PERMIT

SEWAGE DISPOSAL SYSTEM

SUBDIVISION Slack Estates LOT 6 ROAD 2050 St. James Road

REPAIR - PURPOSE - SEPTIC SYSTEM IS FAILING (GROUNDWATER INFILTRATION)

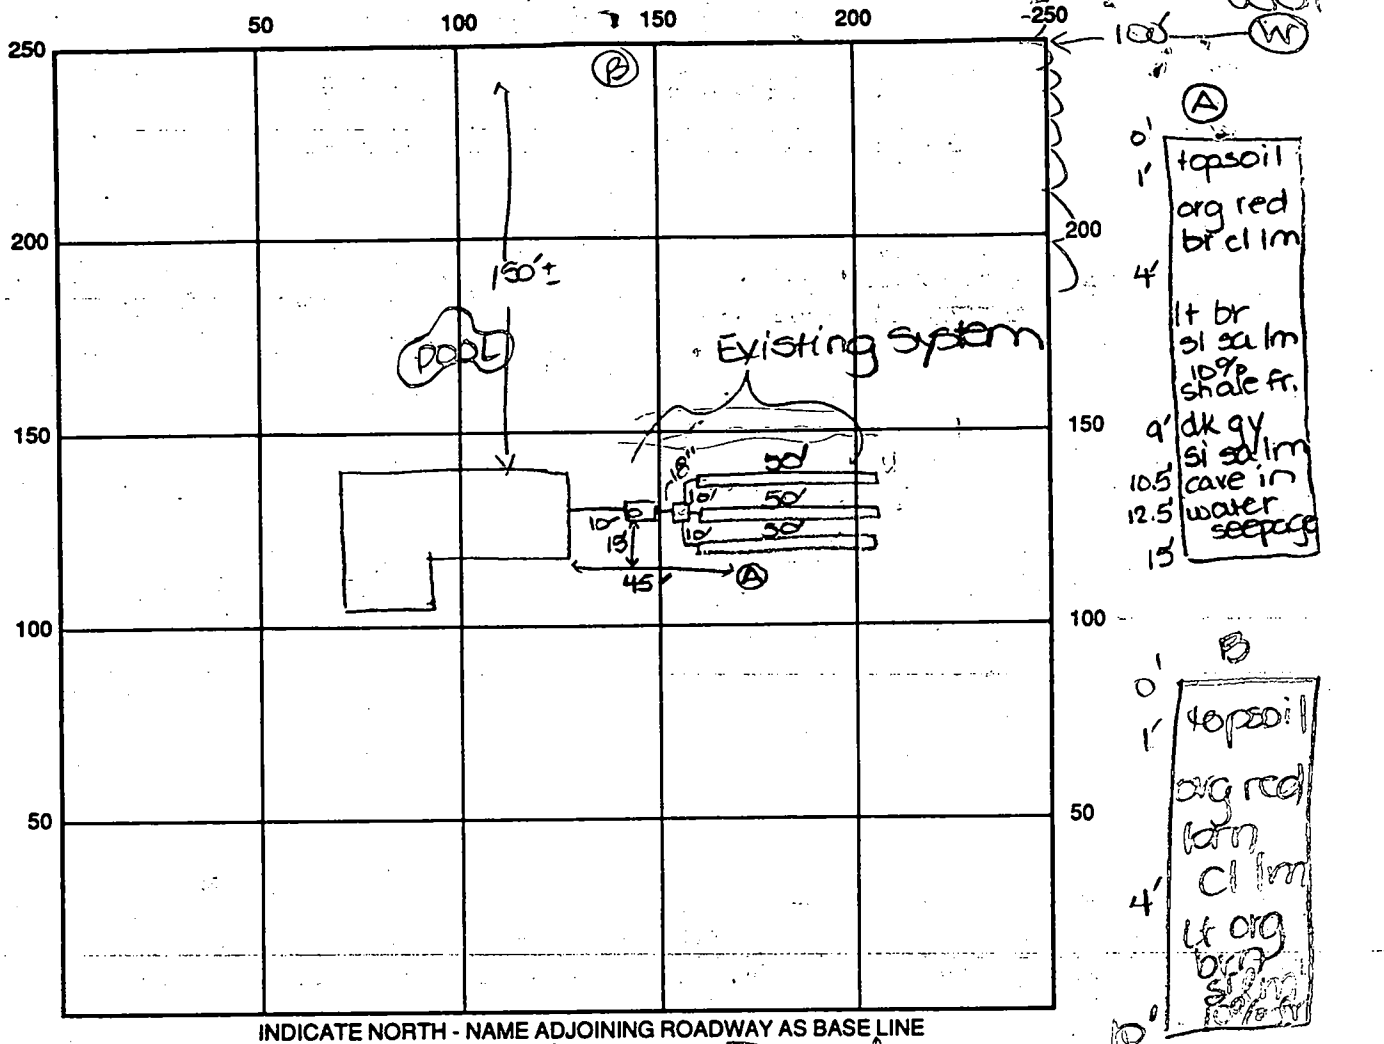
SPECS REVISED (TWO OPTIONS) ATTACHED
FIELD MEETING ON 6/27 - SEE ATTACHED (CW)

TRENCHES - Trench to be 4 feet wide. Inlet as shallow as existing plumbing allows.
One foot of stone below distribution pipe.

LOCATION - Trenches to be installed directly upslope of existing trenches, in highest part of septic area, approximately.

OB Trenches to be 3' wide, inlet 4', bottom 5', stone 1'.
Total trench length 240'.

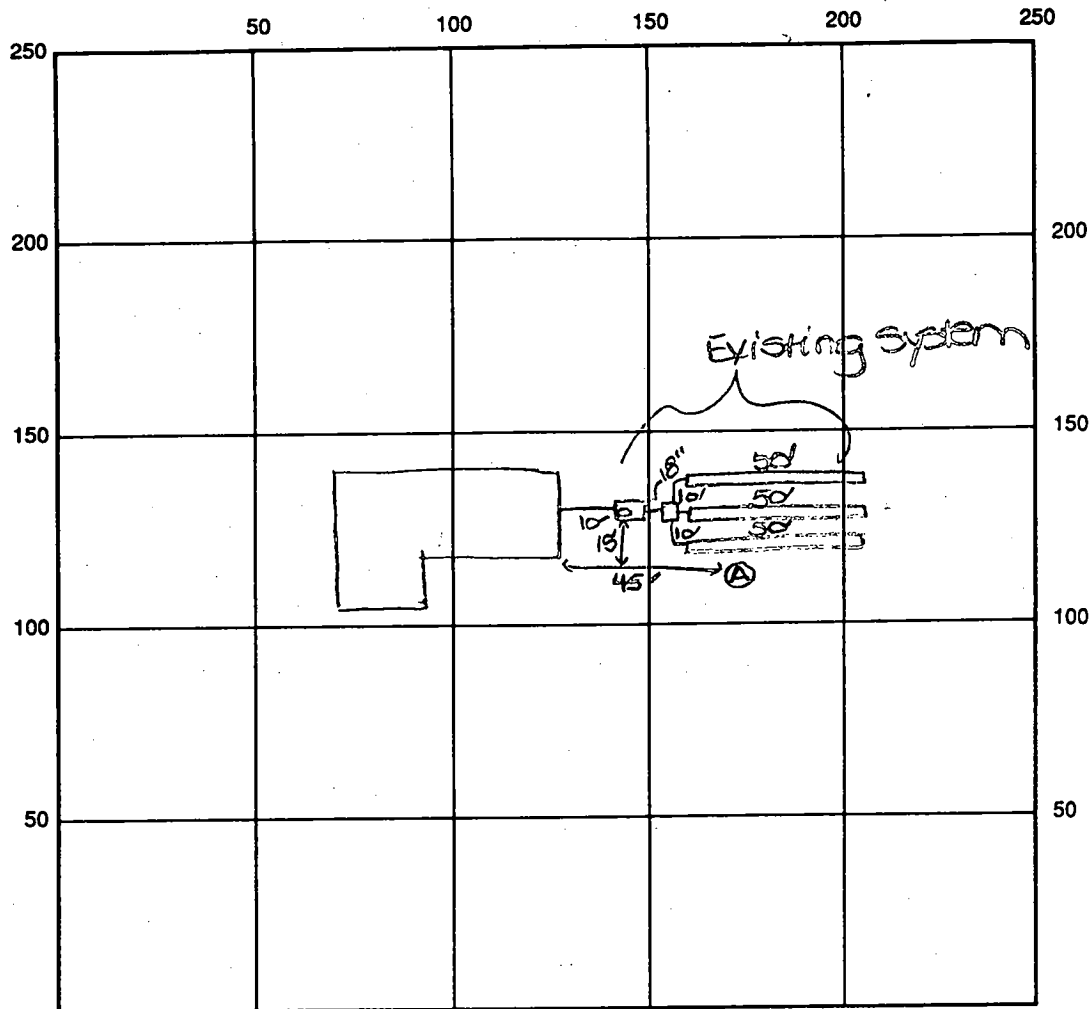
REPAIR - PURPOSE - SEPTIC SYSTEM IS FAILING (GROUNDWATER INFILTRATION)

TRENCHES - Trench to be 4 feet wide. Inlet as shallow as existing plumbing allows.
One foot of stone below distribution pipe.

LOCATION - Trenches to be installed directly upslope of existing trenches, in highest part
part of septic area, approximately.

(A)
 0' topsoil
 1' org red
 4' br cl lm
 1' lt br
 sl ea lm
 10% shale fr.
 9' dk gy
 si sa lm
 10.5' cave in
 12.5' water
 15' seepage

REMARKS: 10/11/96 observation perc hole showed evidence of
water table - test hole open 30 minutes ±. Depth of
closest existing trench 9.5' deep. DKS

A 35154

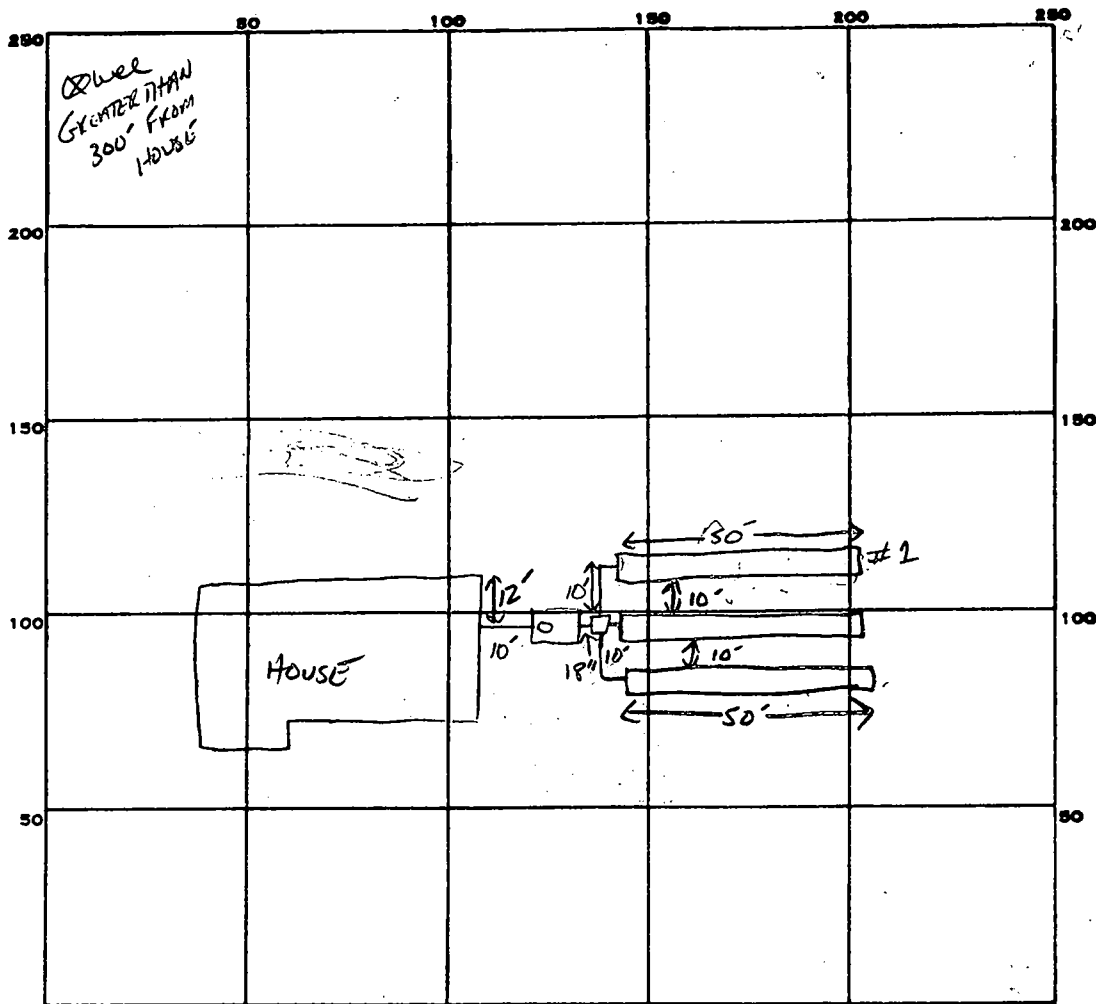
REMARKS 8-1-85 OK TO ADD STONE TO TRENCH #1 AND DIG #2+3 AND AS STONE AS NEEDED 5 Abel

8-1-85 OK TO ADD STONE TO ALL TRENCHES

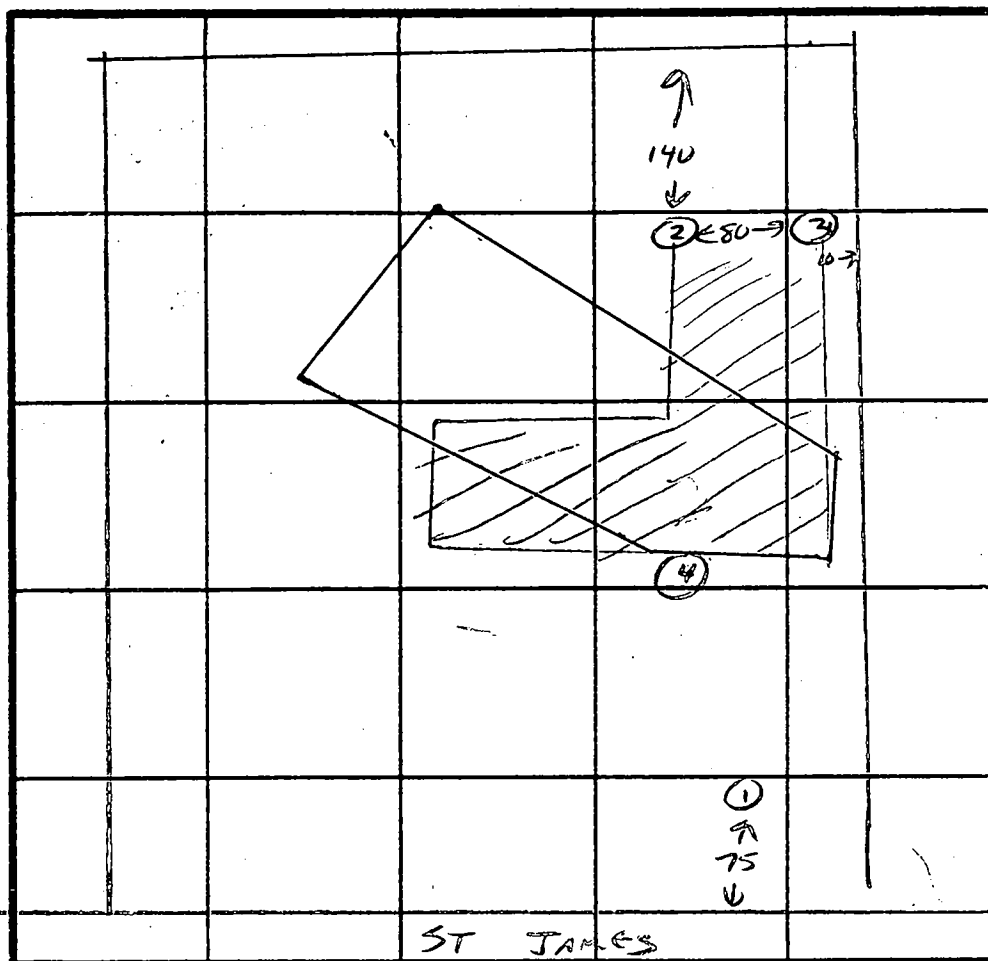
REMARKS DARK OUTLINE IS ORIGINAL PERC AREA / SHADED FIGURE IS ADJUSTED PERC AREA.

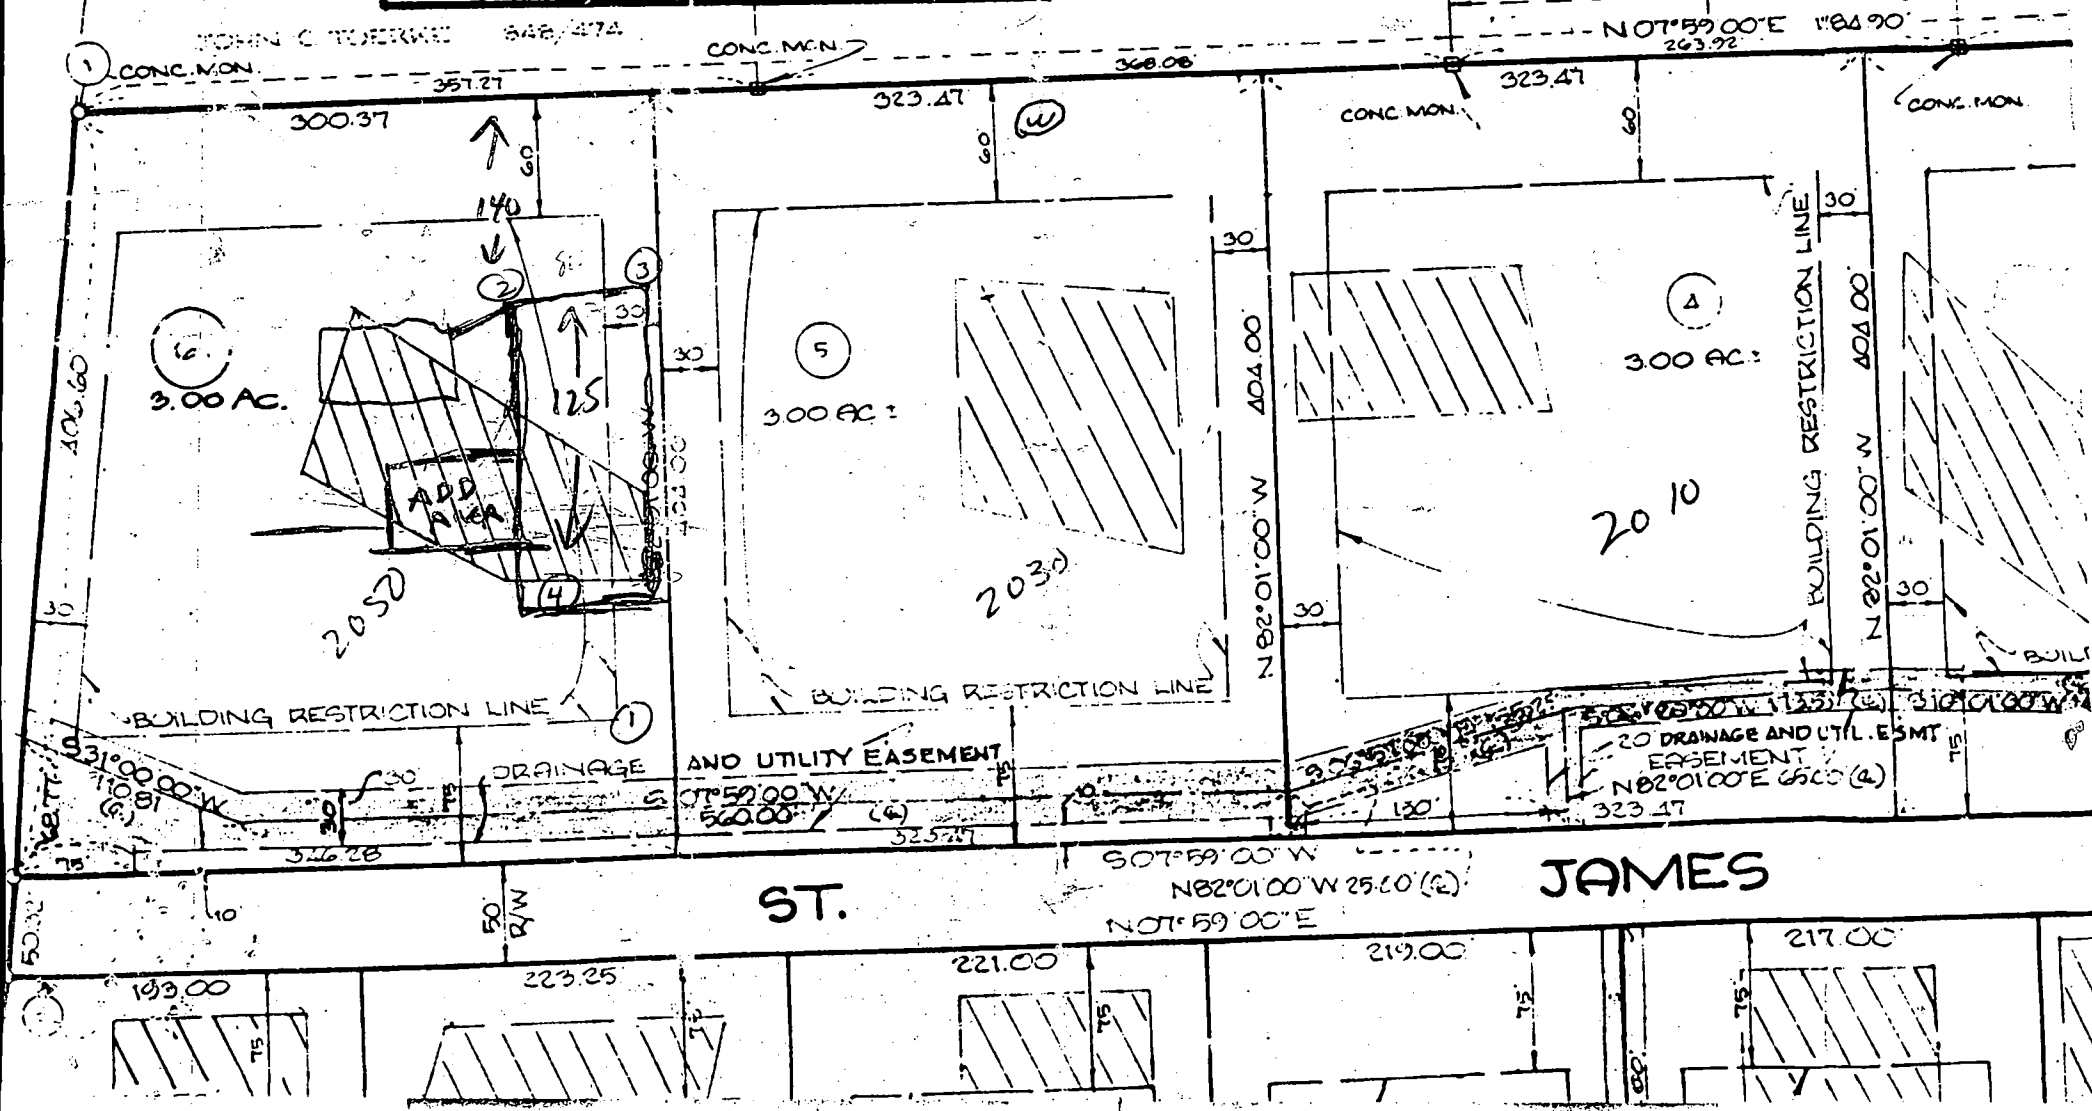
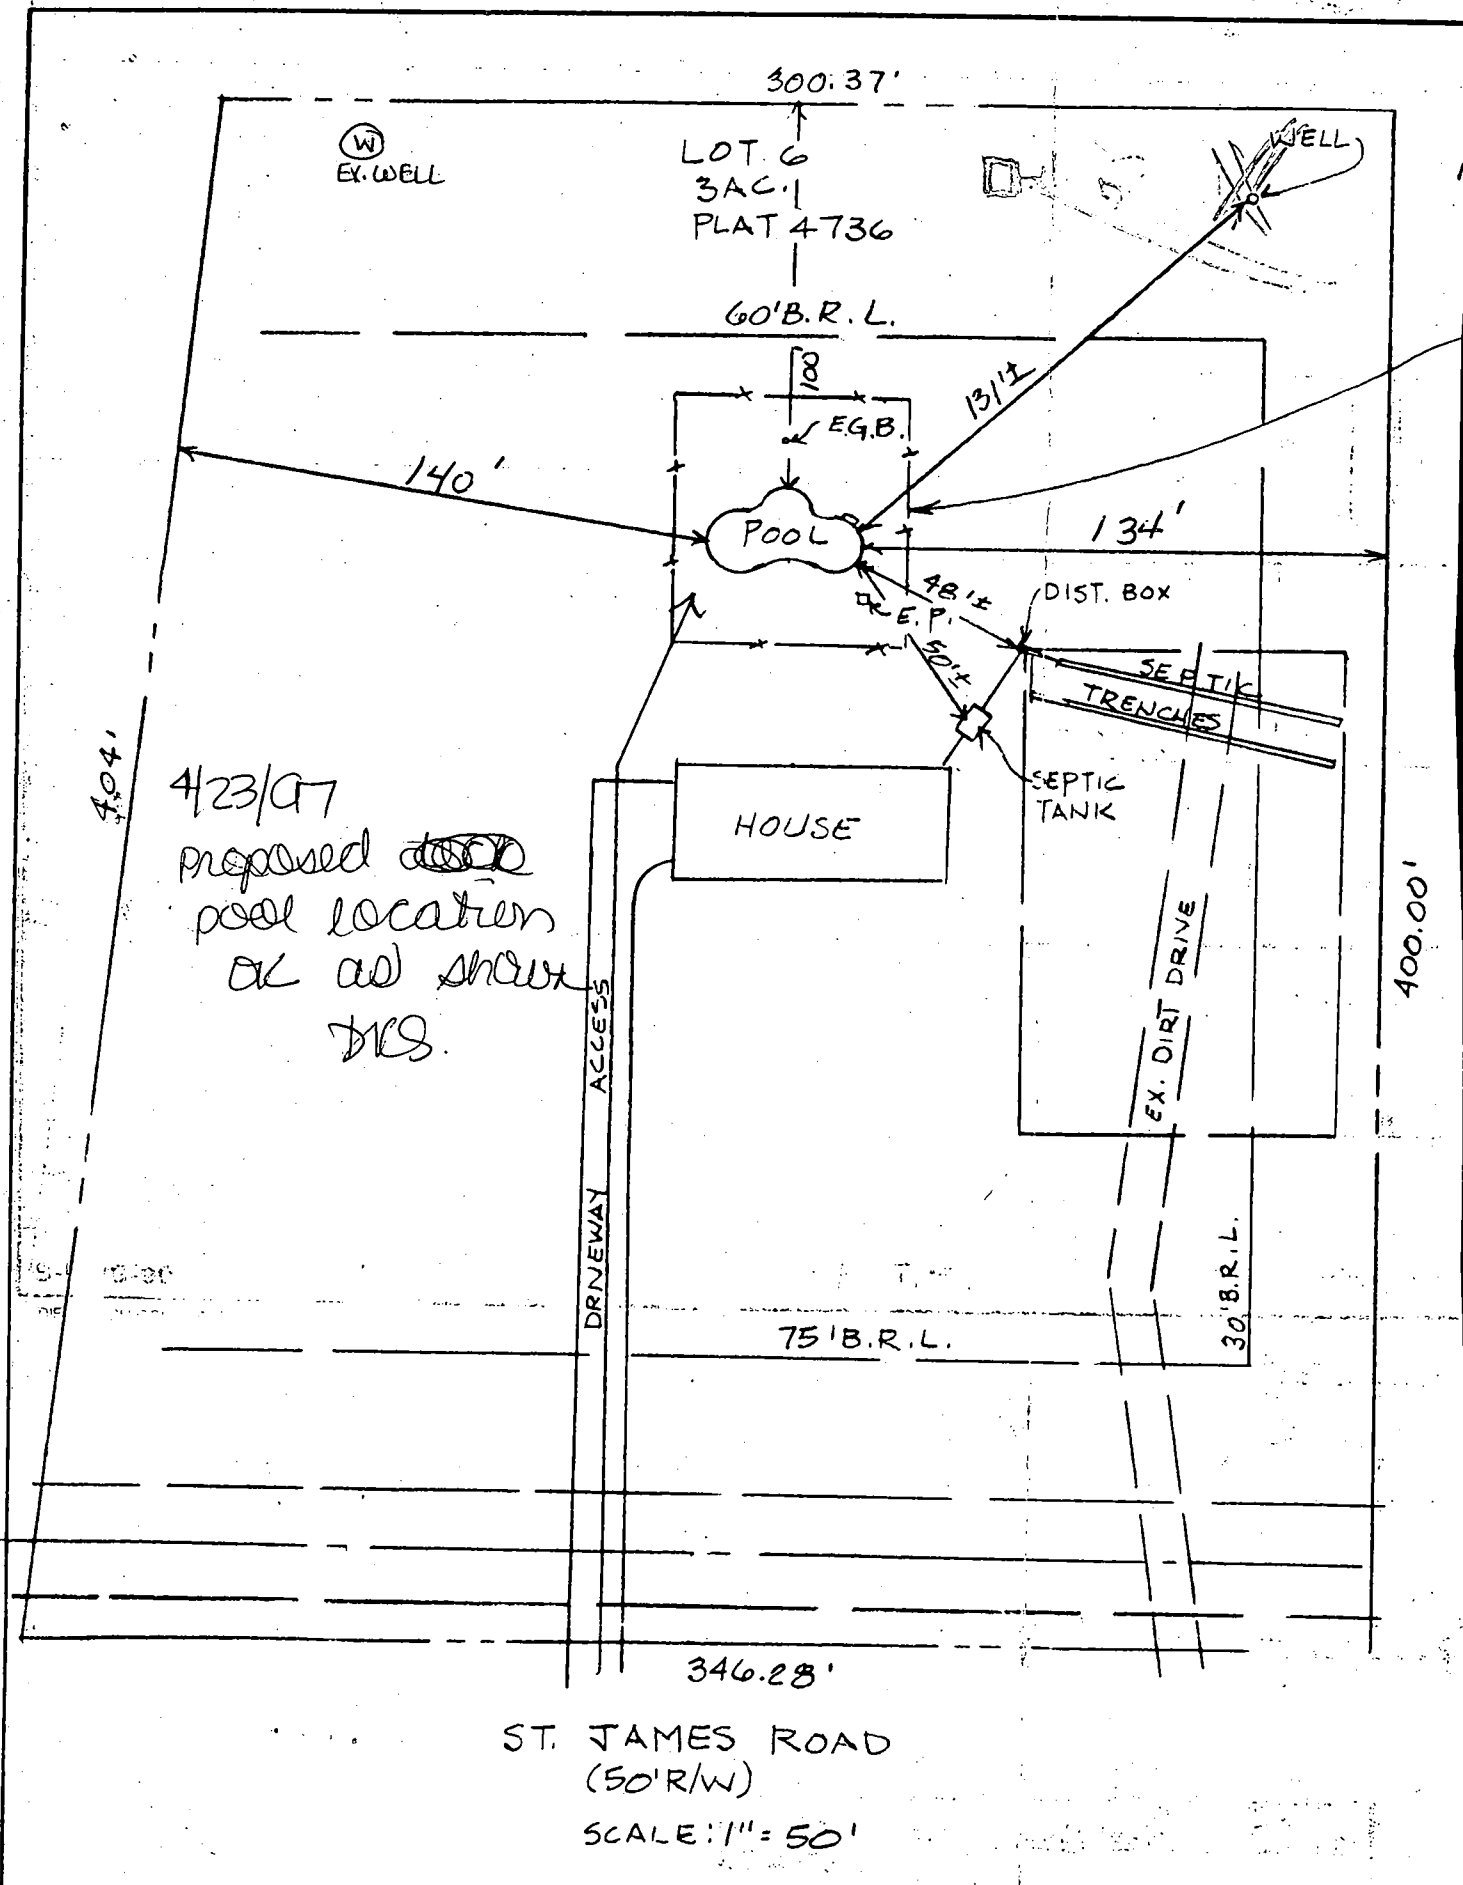
180 SQ FT / BEDROOM

INLET 4' BELOW GIN NOSE } 6' STONE
BOTTOM 10'

LOCATED FIRST TRENCH

140 FROM REAR + 90 FROM RIGHT

LEAVE SPECS AND

ADJUSTED PLAT
